工程指示 / 要求簡箋(E.I.)

工程指示編號：EI / 9712 / 18

工程名稱：觀塘裕民坊

工程項目：後裝窗樣板 (T2M) (6/F)

T2W
M-1

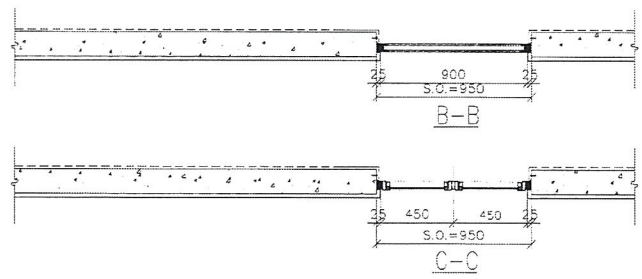
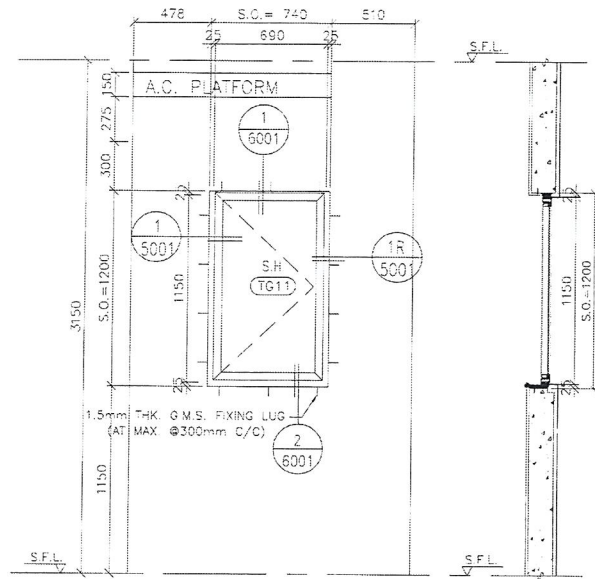
plenum box
中間片
雙邊 plenum box
要有中間片

窗樣板

T2W
M-Z

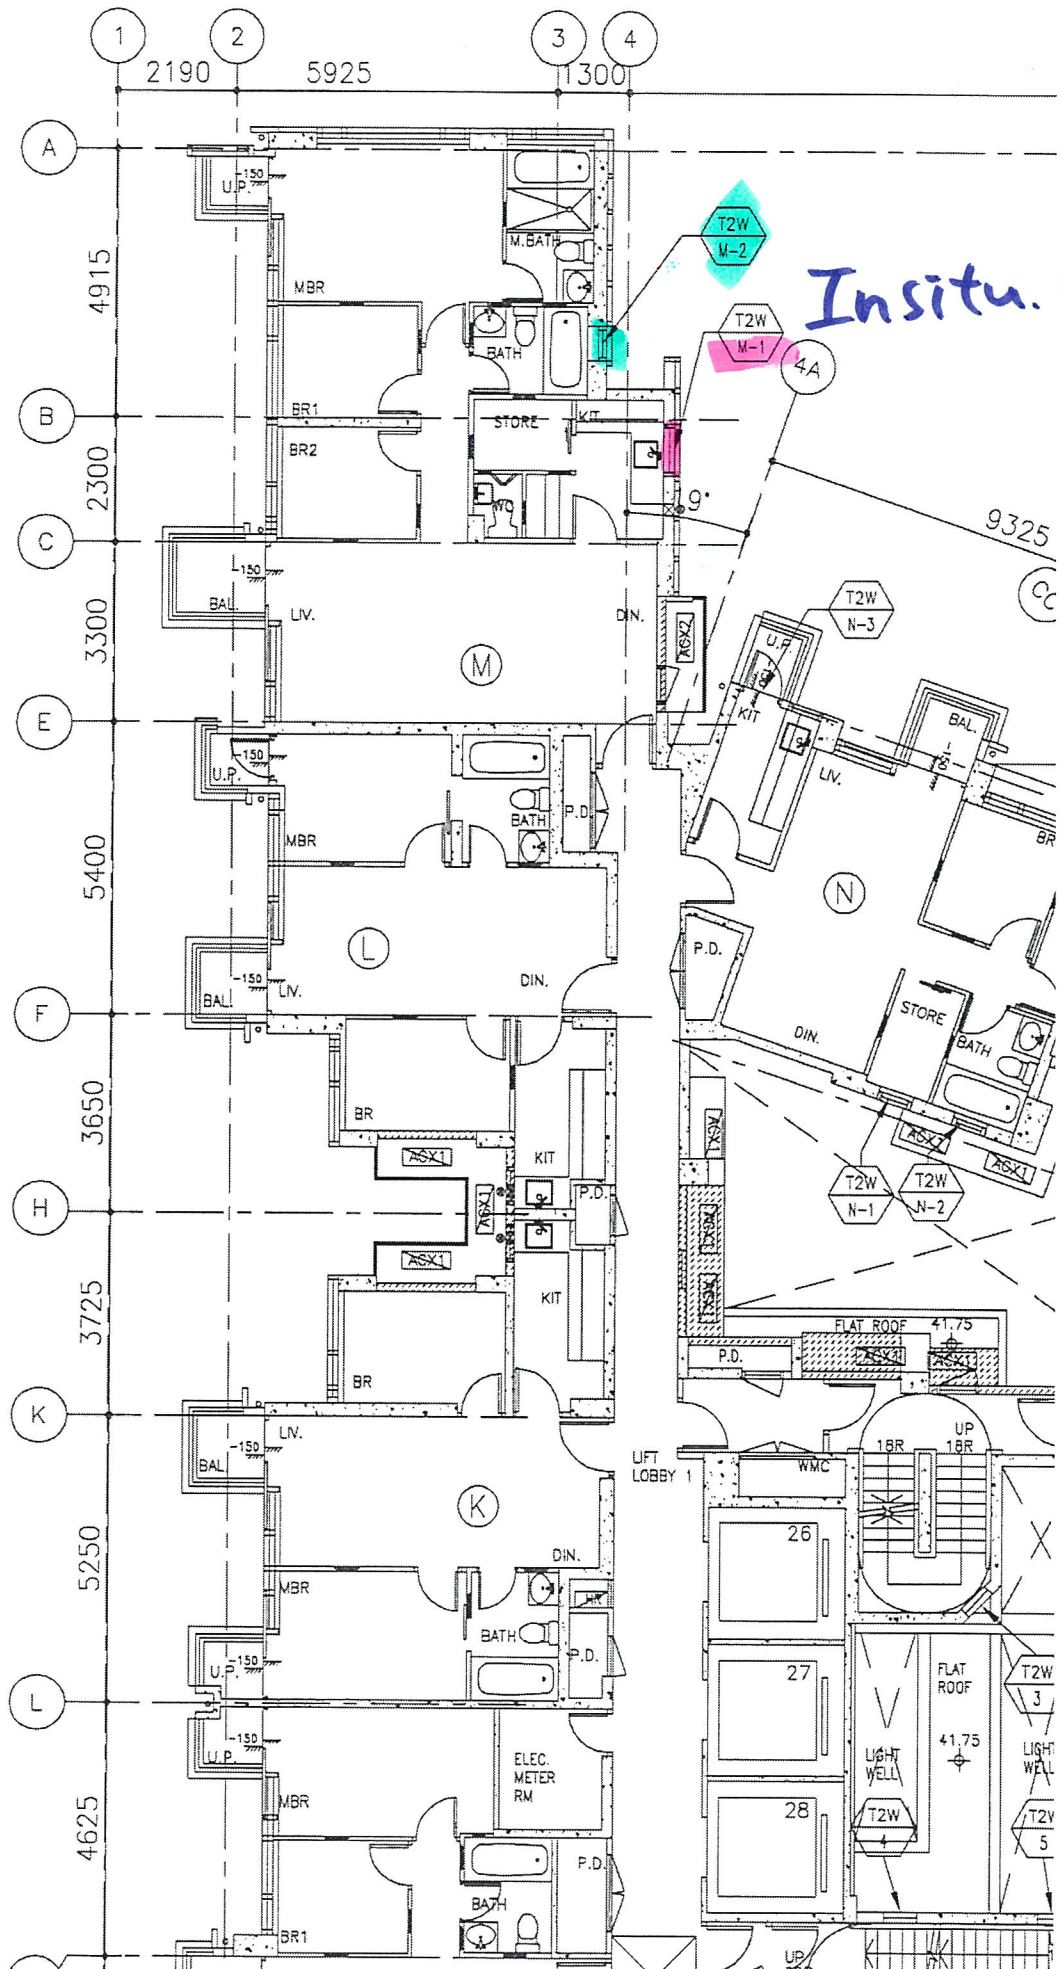
plenum box

一隻樣板

2 ELEVATION OF ALUM. PLENUM BOX AT LOUVRE
NTS

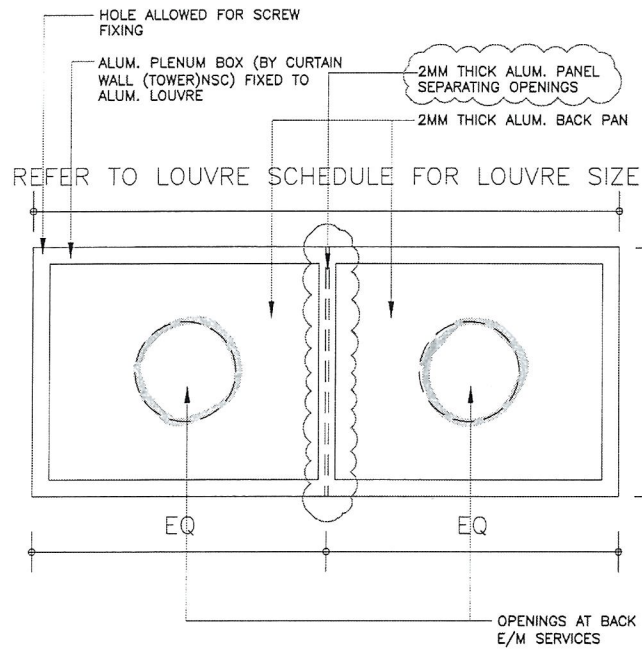
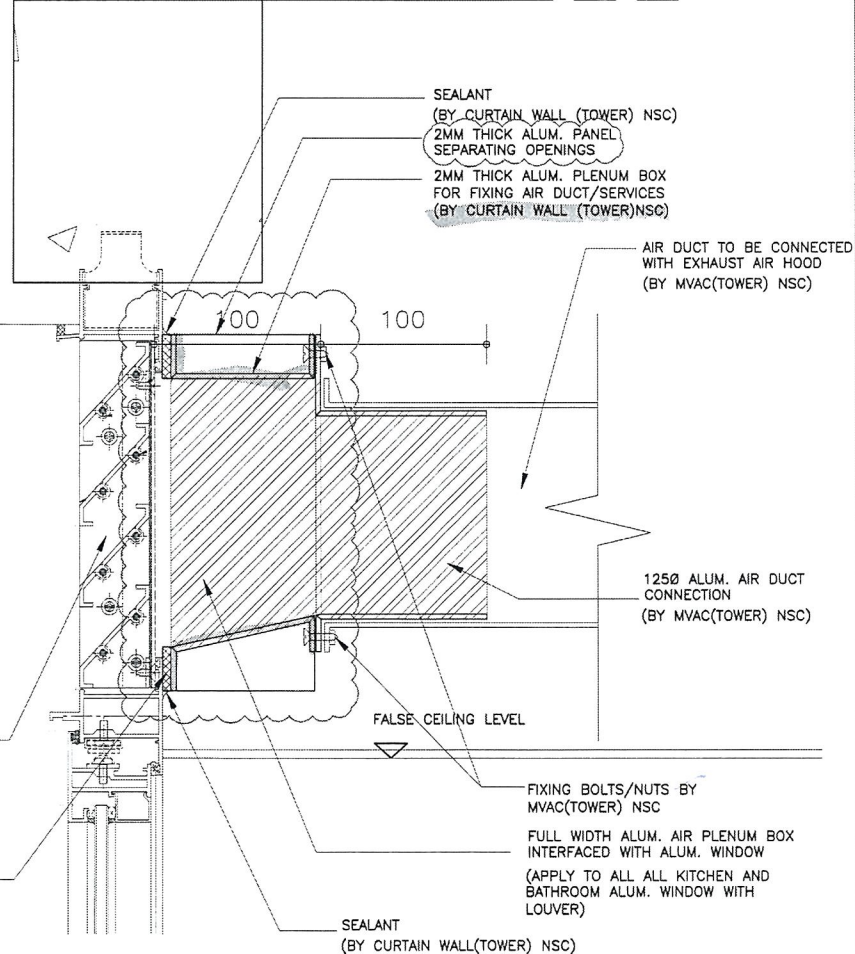
字樣大圖增加此 plenum 箱

** plenum box*

中間片
